April 11, 2011
U7-C-NINA-NRC-110059

South Texas Project
Units 3 and 4
Docket Nos. 52-012 and 52-013
Supplemental Response to Request for Additional Information

RAI 03.07.01-2, Supplement 2**QUESTION:**

Figure 3H.8-18: Target vs. Computed Response Spectra, V1 Component, 7% Damping

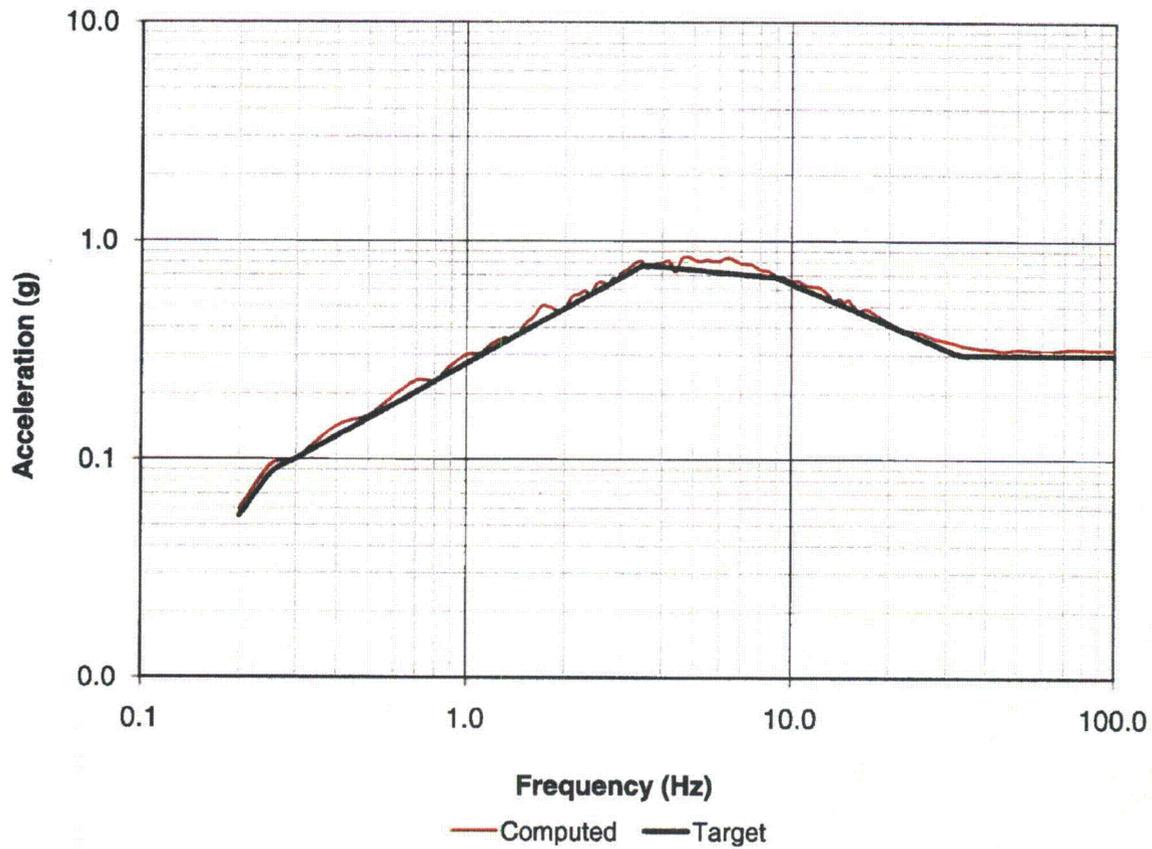
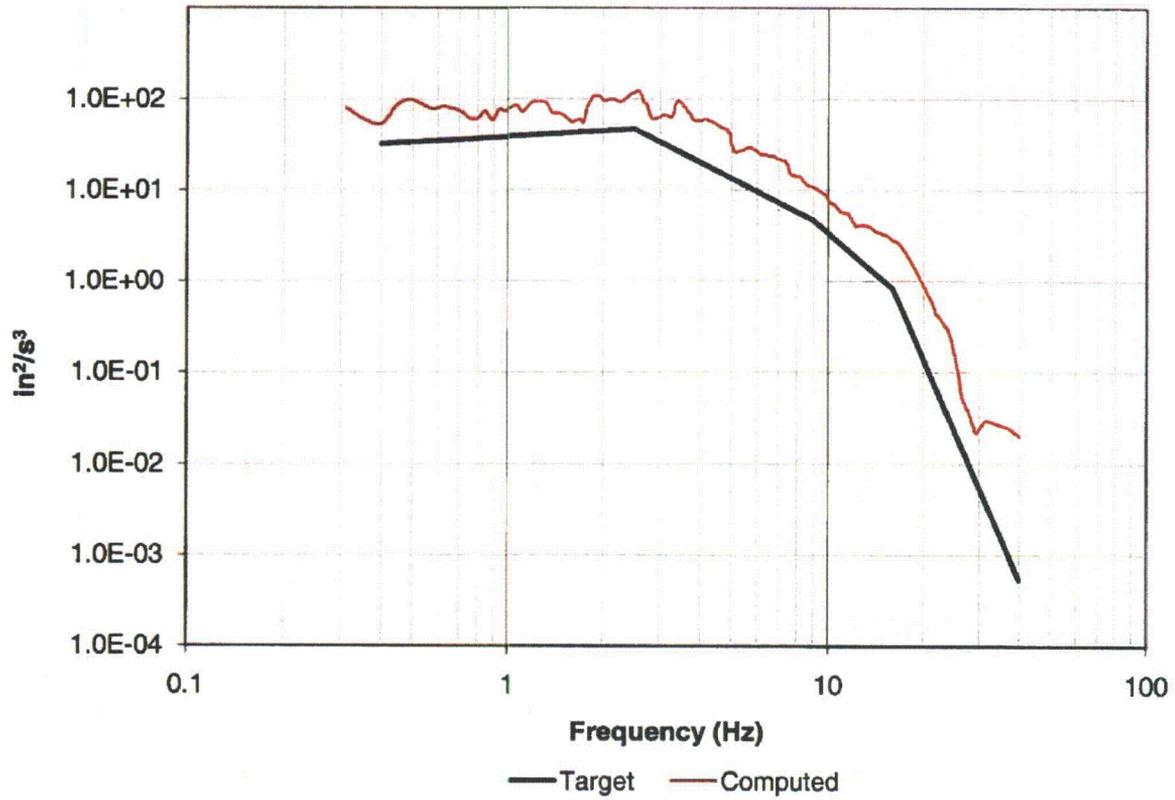
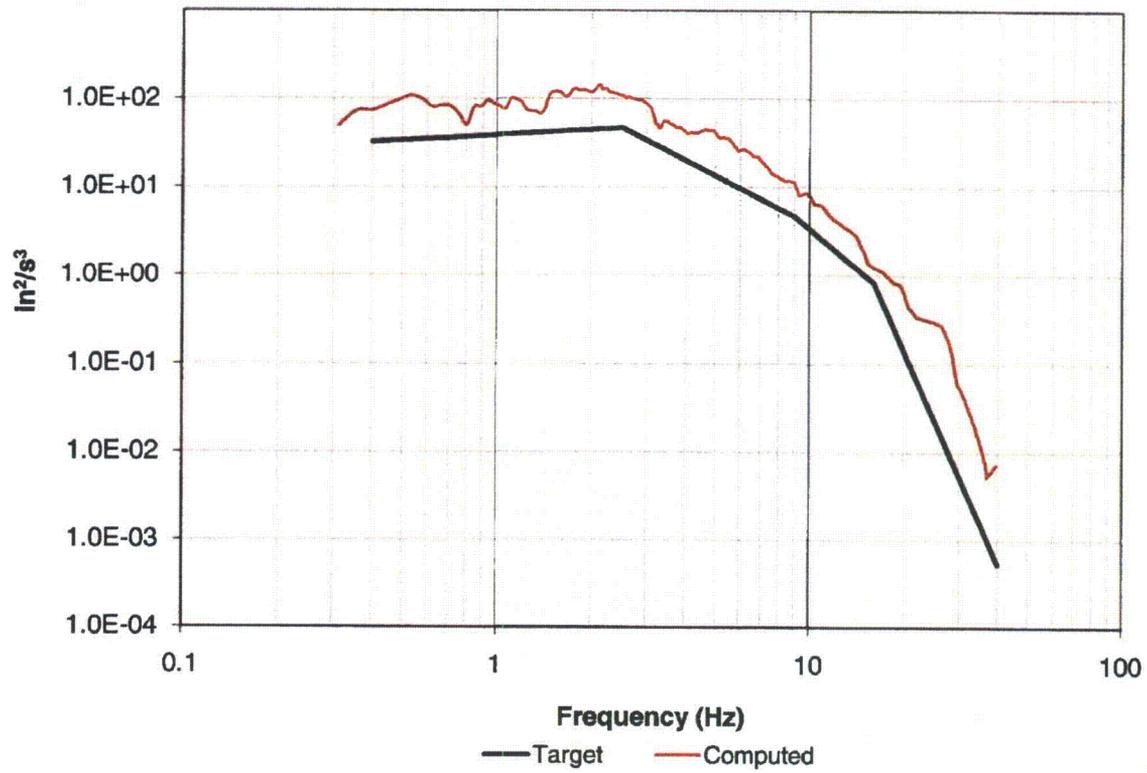
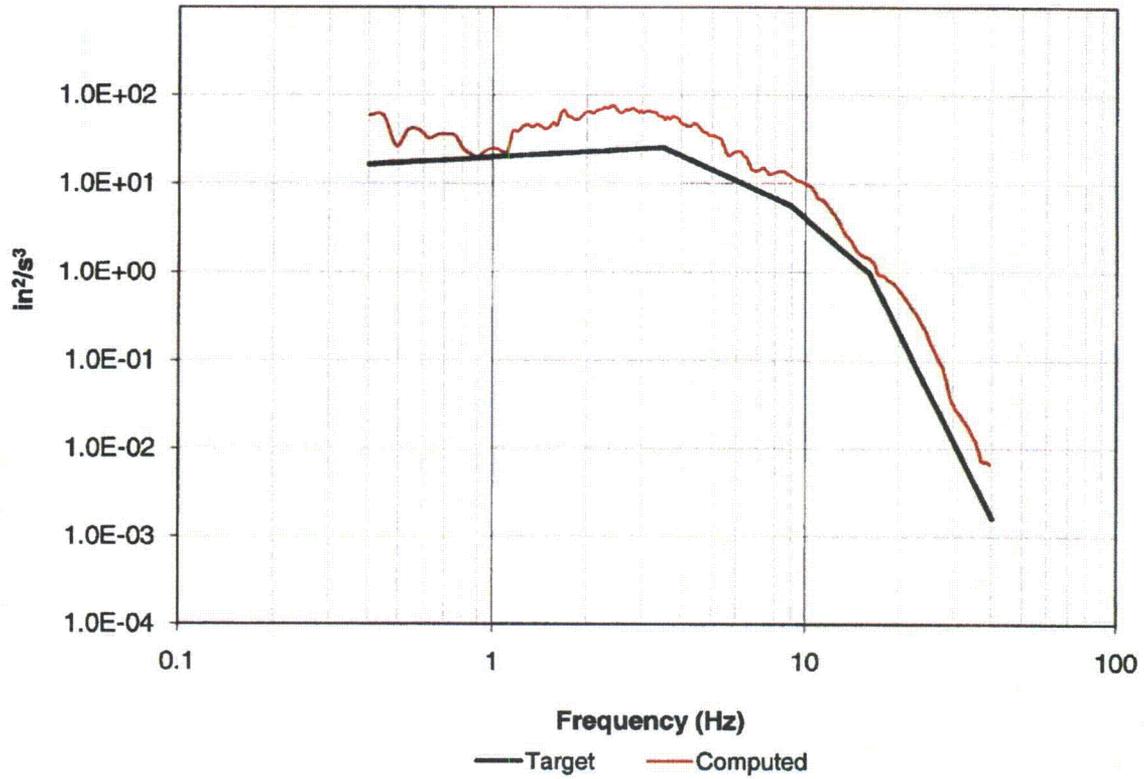
1. Site-specific SSE design response spectra for all applicable damping values (include specific figures) used for seismic reconciliation with the standard plant results as well as for site-specific seismic analysis and design of applicable site-specific structures (Ultimate Heat Sink, and Reactor Service Water (RSW) Piping Tunnel.)
2. Site-specific statistically independent three components of SSE design time histories and their bases that apply for the site-specific analysis.
3. Site-specific Operating Basis Earthquake (OBE) to be used for setting up the seismic instrumentation (FSAR Section 3.7.4).

The original response to this RAI, submitted with letter U7-C-STP-NRC-090105, dated August 20, 2009, provided information on the site-specific Safe Shutdown Earthquake (SSE) time histories. In the seismic analyses performed for the Diesel Generator Fuel Oil Tunnel and Diesel Generator Fuel Oil Storage Vault, consistent time histories for the Certified Seismic Design Response Spectra are required. These time histories were developed and subsequently reviewed during the NRC Audit of March 14-18, 2011. The NRC Staff requested that information on these time histories be added to the COLA to reflect the analysis performed for the Diesel Generator Fuel Oil Tunnel and Diesel Generator Fuel Oil Storage Vault.

The seismic analysis of the Diesel Generator Fuel Oil Storage Vaults and Diesel Generator Fuel Oil Tunnels use the SSE ground motion included in Tier 1 Table 5.0, in addition to the site-specific SSE ground motion, as described in Sections 3H.6.7 and 3H.7, respectively. Since the DCD does not include the digitized information for the SSE time histories, new time histories consistent with Regulatory Guide 1.60 response spectra anchored to peak ground acceleration of 0.3g were developed for use in these analyses. Acceleration time history records obtained from 1994 Northridge Earthquake were used as seed time histories in generating these synthetic time histories. The time histories were developed in accordance with the criteria described in Section 3.7.1.2, using computer programs SYNQKE-R, HIST, and QUAKE described in Appendix 3C.

The plots of the acceleration, velocity, and displacement time histories of the two horizontal and the vertical components are shown in Figures 3H.8-1 through 3H.8-3. The plots of response spectra for 2%, 3%, 4%, 5%, and 7% damping, showing the comparison of the target response spectra (Regulatory Guide 1.60 spectra) with the spectra of the synthetic time histories, are shown in Figures 3H.8-4 through 3H.8-18. The plots of power spectral density functions (PSD) showing the comparison of the target PSD, corresponding to the Regulatory Guide 1.60 spectra, with the PSD of the synthetic time histories are shown in Figures 3H.8-19 through 3H.8-21.
